ADDENDUM #6

PROJECT : CODESTACK ACADEMY

REF. # : ARCH PROJ. No. 2023-04

DATE : 21 March 2025

BB TRASH ENCLOSURE- FLOOR PLAN
1/4" = 1'-0"

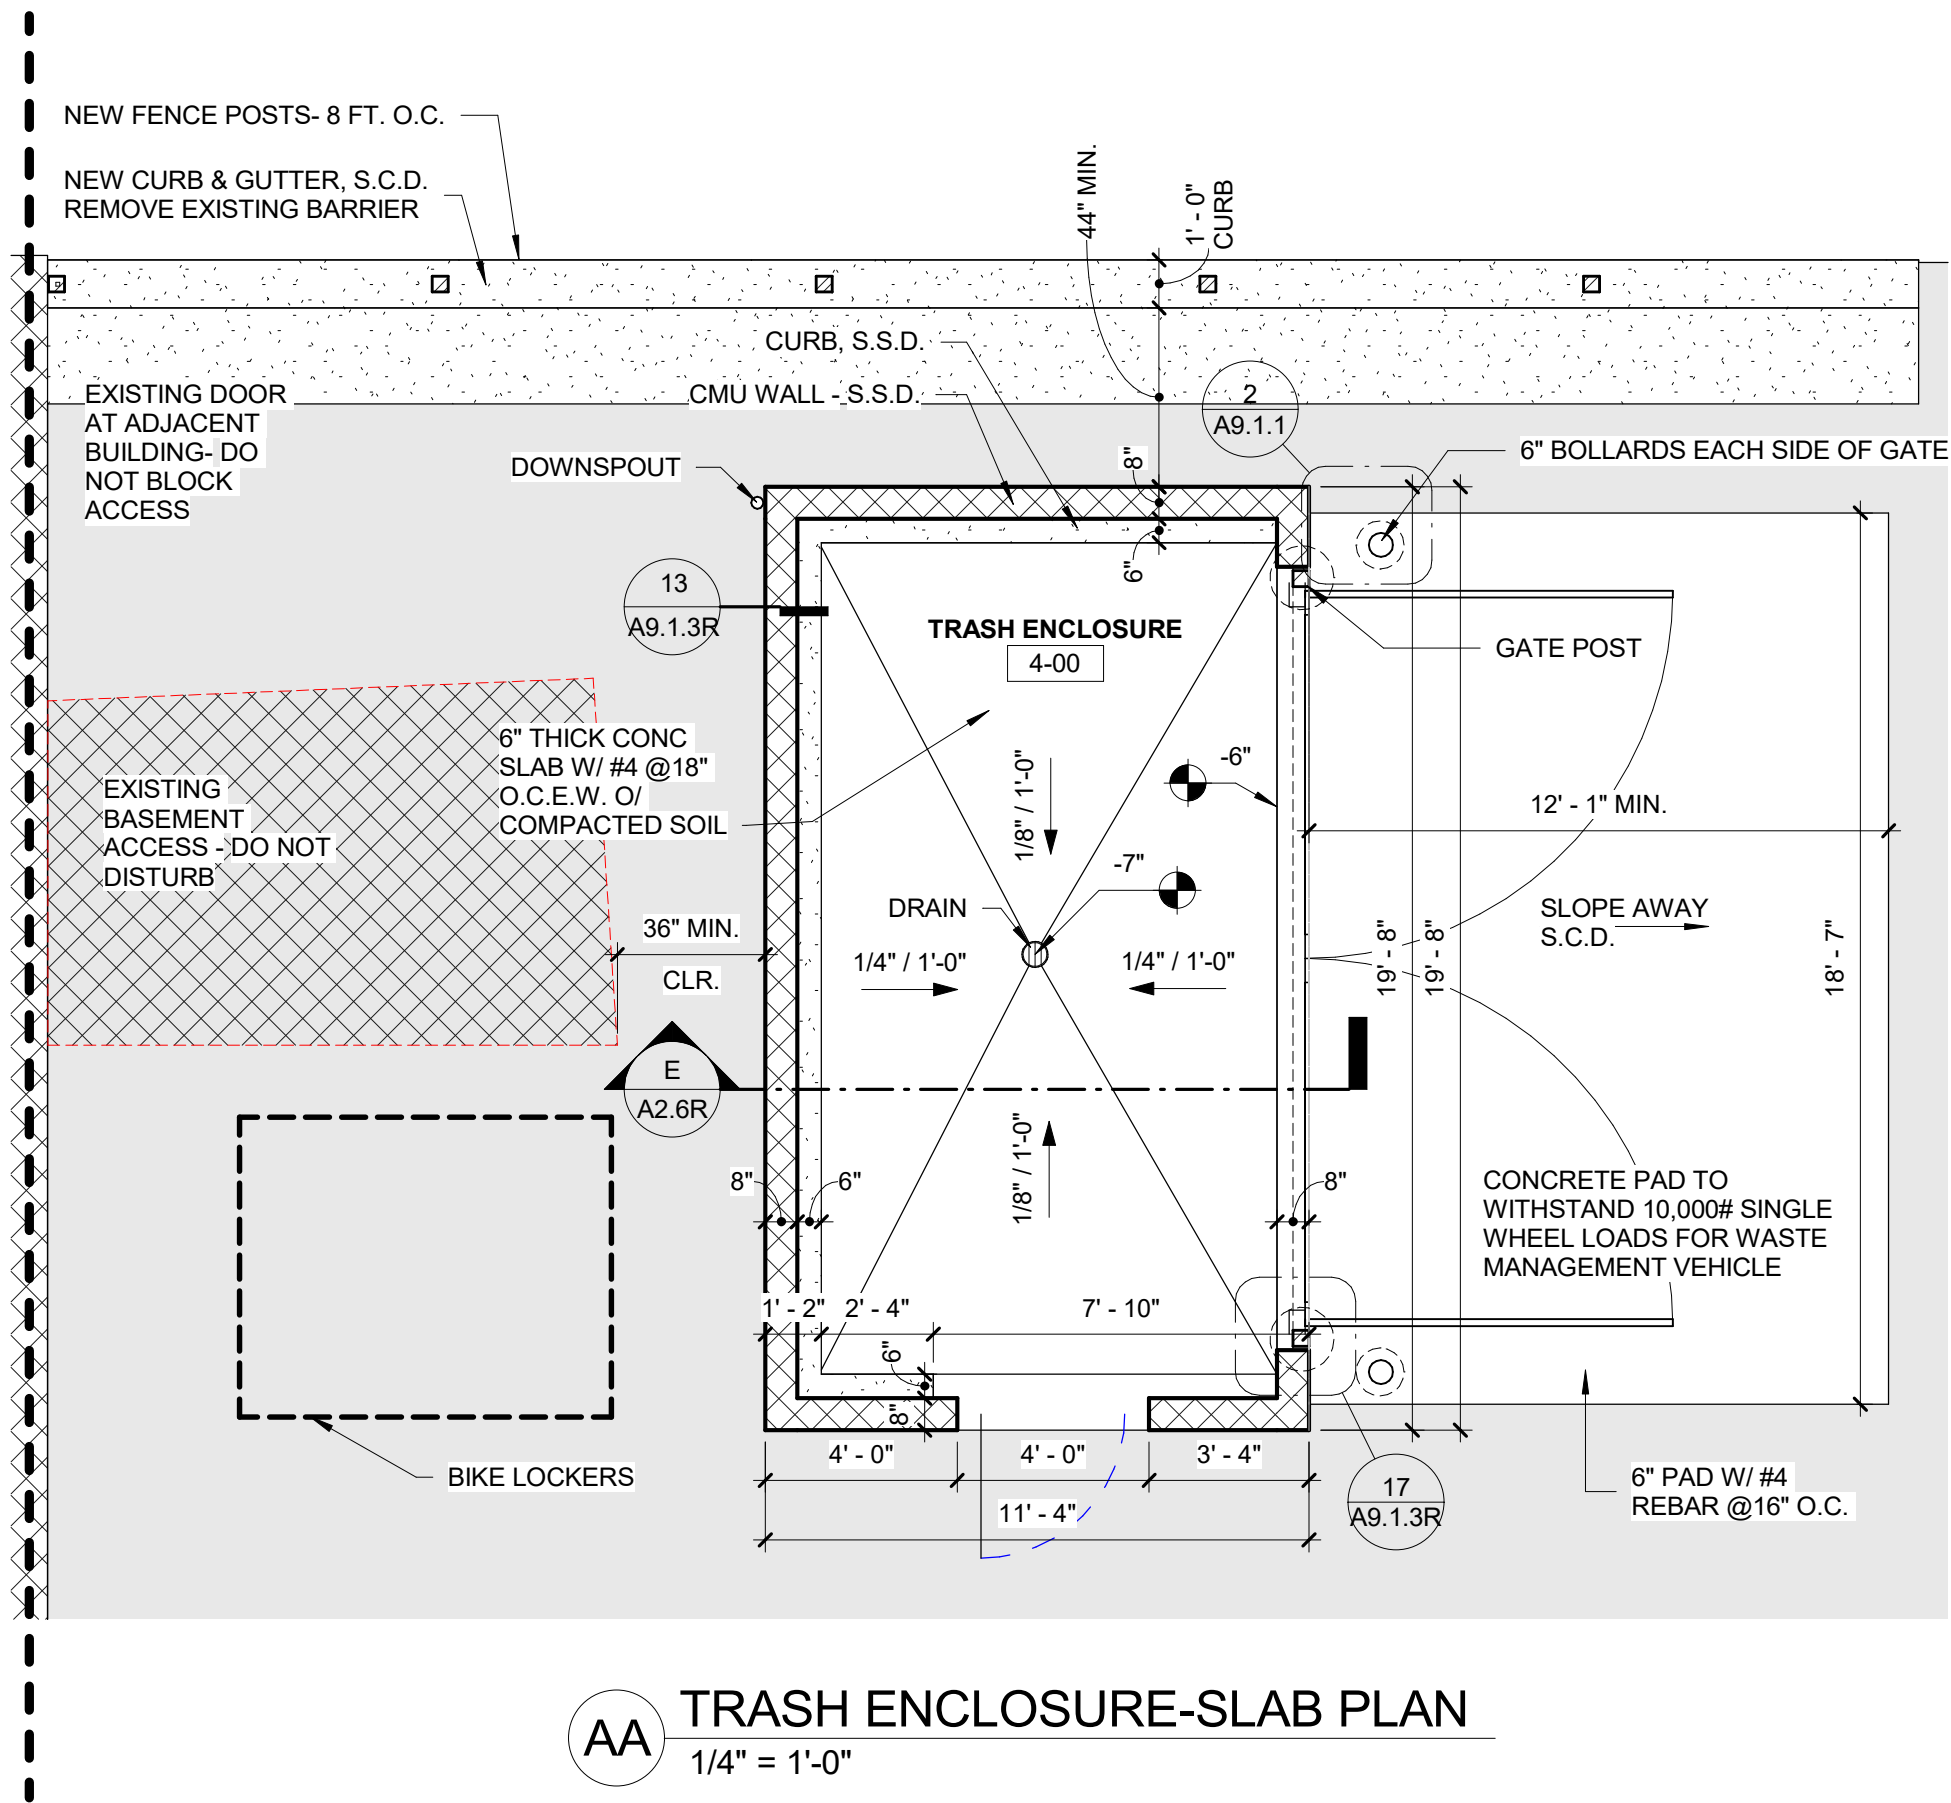
Are there any structural details for trash enclosure? Details D & E on A2.6 and 16/A9.1.3 refer you to structural drawings for roof framing at trash enclosure. Please confirm what structural details are to be followed for roof framing and sheeting at trash enclosure.

RESPONSE: New Architectural details have been provided for the trash enclosure Roof framing and foundation plan. See revised sheet A9.1.2R Details 4, 7, 8, & 12. (attached). See also, revised sheet A2.6R (attached) for revised detail callouts.
